Project K.T. WIEDEMANN

Item CHANNEL RE-DESIGN

REFERENCE: Channel realignment and re-design

SUBJECT DP-88 Wiedemann Business Park CUP

PROPOSED DESIGN CHANNEL

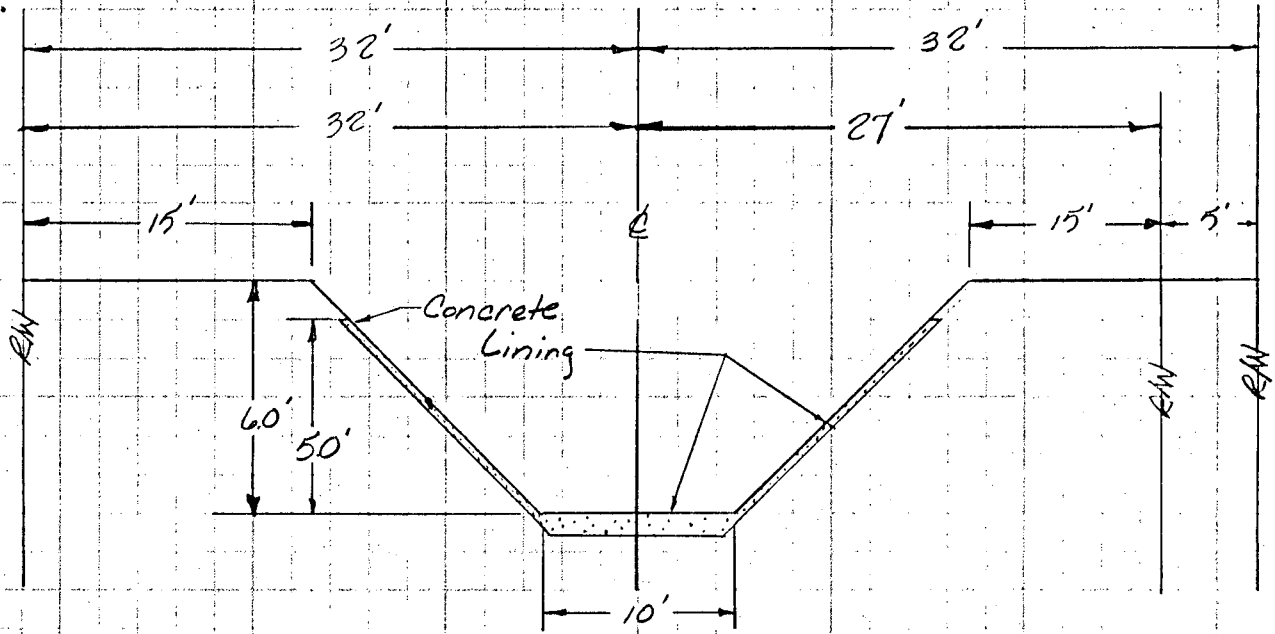
As per your conversation this morning with Dick Linn, our client wishes to amend the design channel for that portion of a tributary to Four Mile Creek which crosses the northeast corner of the property being platted as K.T. Wiedemann Business Park. Enclosed are the re-design calculations along with the proposed re-alignment of the portion of the channel within K.T. Wiedemann. If you have any questions, please contact either Dick Linn or myself.

(Concept)
Plan, as presented ~~is~~ was acceptable based on reworking the outlet transition of the concrete to earthen (grass lined) ditch. Special design of this transition will be required (see page 313, open channel Hydraulics by Ven Te Chow) and should be considered in the cost estimate.
